July 26, 2022

RE: COMMENTS ON THE HAZELWOOD MINE CLOSURE PROPOSAL

Figure 2 Coal Block Sliding Mechanism

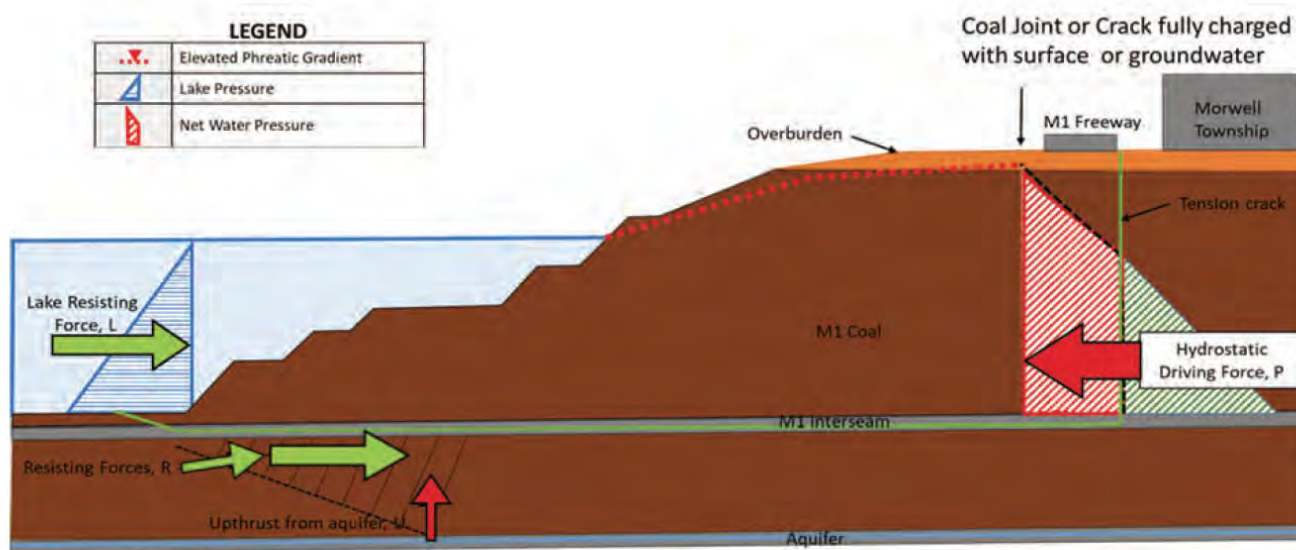
One of the reasons for using water to fill the mined-out pit is to avoid pit floor heave and batter collapse. While adding a pit lake would lessen both pit floor heave and batter collapse stresses, it would also raise the water table in the pit walls that are not submerged in the lake, which would increase the likelihood of batter collapse for those unflooded batters. This effect is illustrated in Figure 2 (Narendranathan 2021)

below. This is only an illustration, not a depiction of actual conditions, but note the phreatic surface (i.e., the groundwater level, the red dashed line) that has been raised to meet the surface of the lake. Whether this rise in the phreatic surface will be problematic will depend on the actual steepness of the slope of the unsubmerged pit, and the saturated and unsaturated strength of the pit wall materials.

A pit lake could have both positive and negative implications for batter collapse. The fundamental closure decision with regard to pit backfill to mitigate floor heave and batter collapse is what to use as backfill – water or solid waste. It is obviously much less expensive to use water, and that is the only solution that appears to have been seriously analyzed at this time. Water availability and potential water contamination from the mine and mine waste are potential fatal flaws to a lake-fill closure approach.

ERM Figure F1 - Site Locality Plan and Layout

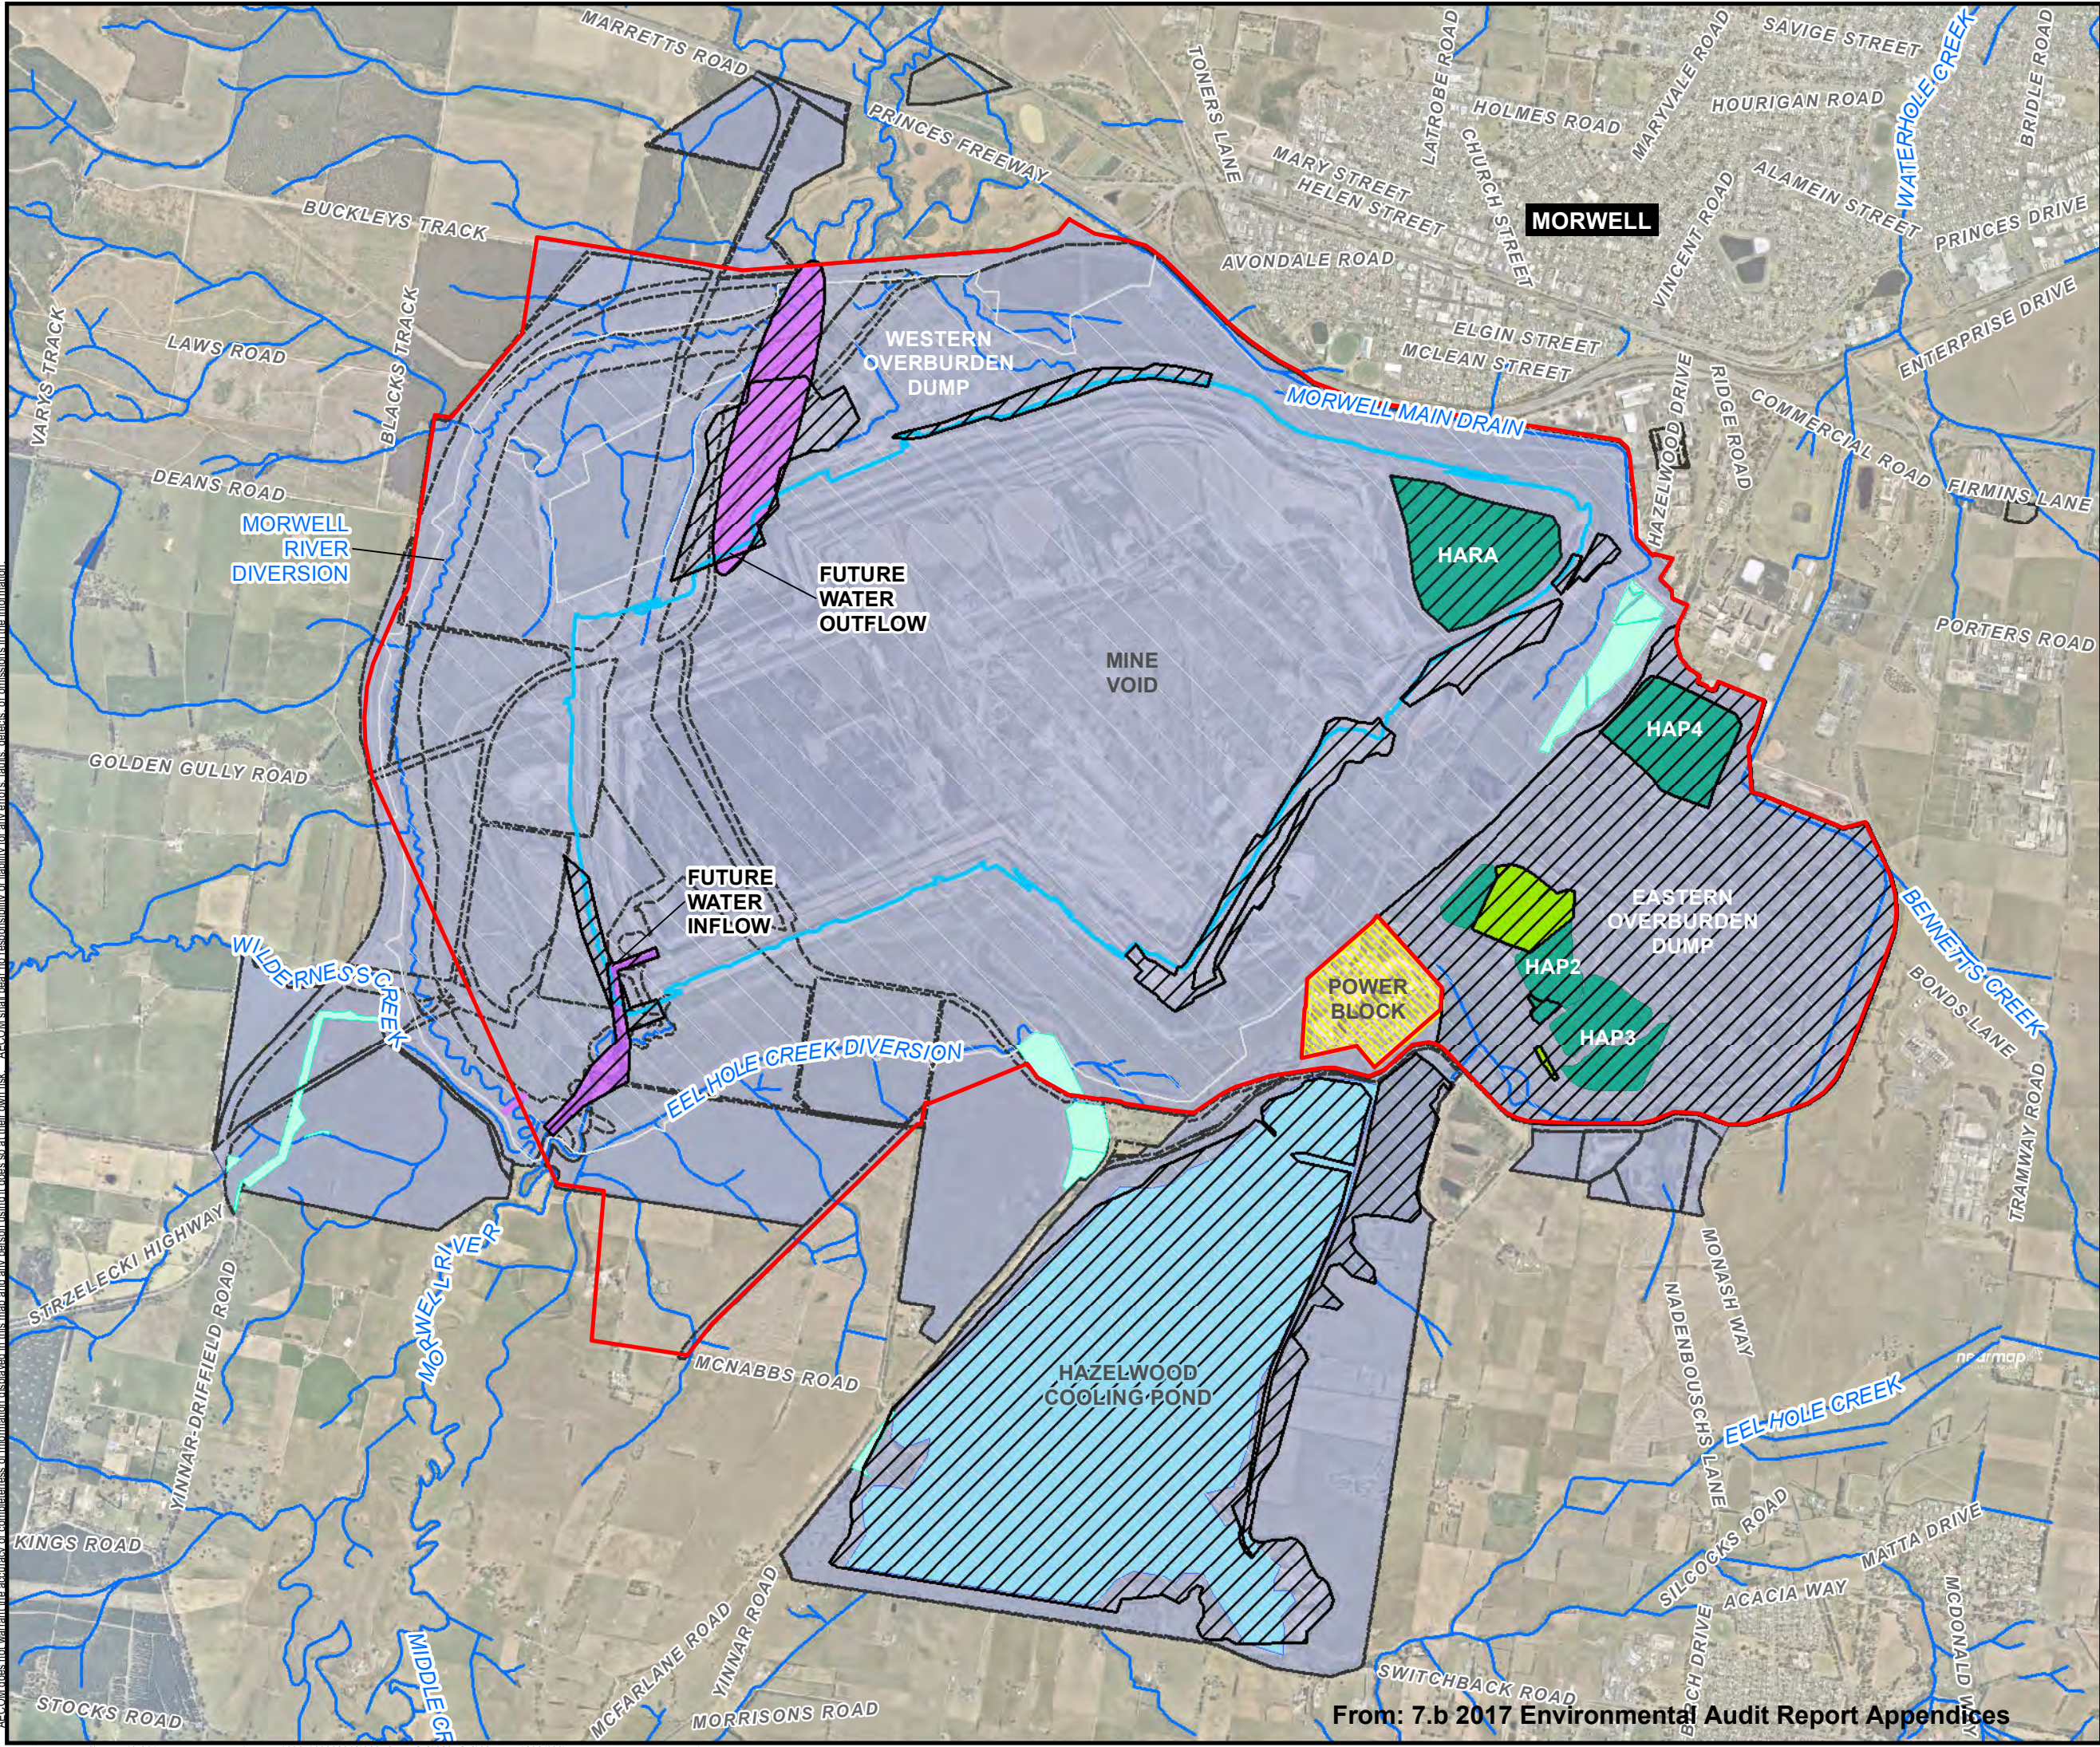
The ash facilities are Hazelwood Ash Pond 1 (HAP1), Ash Pond 2 (HAP2), Ash Pond 3a (HAP3a), Ash Pond 3b (HAP3b), Ash Pond 4 (HAP4), and Hazelwood Ash Retention Area (HARA). (AECOM 2017). These facilities can be seen in ERM Figure F1 Site Locality Plan and Layout, attached to this document.

The potential for ash contamination to affect surface waters is probably greatest if the pit-flooding scheme is adopted, since pit lake water would cover the Hazelwood Ash Retention Area and could potentially be contaminated by groundwater from the Ash Ponds, which are immediately hydraulically upgradient from the proposed lake. If the pit lake water were to become contaminated, then the Morwell River could be affected by this contamination.

The asbestos facilities are: Asbestos Dump 1 (ASB1), Dump 2 (ASB2), and Asbestos Dump No.3 (ASB3). These dumps historically received all asbestos wastes and potentially other waste, such as chromium refractory waste, where it may have been contaminated by asbestos (AECOM 2017). These facilities can be seen in ERM Figure F1 Site Locality Plan and Layout, attached to this document.

However, it is noted that the Hazelwood asbestos storage areas might also contain chromium refractory waste. As a result, groundwater testing beneath the asbestos dumps should be done to determine whether chromium, or other heavy metals, have been leached into groundwater beneath the asbestos dumps.
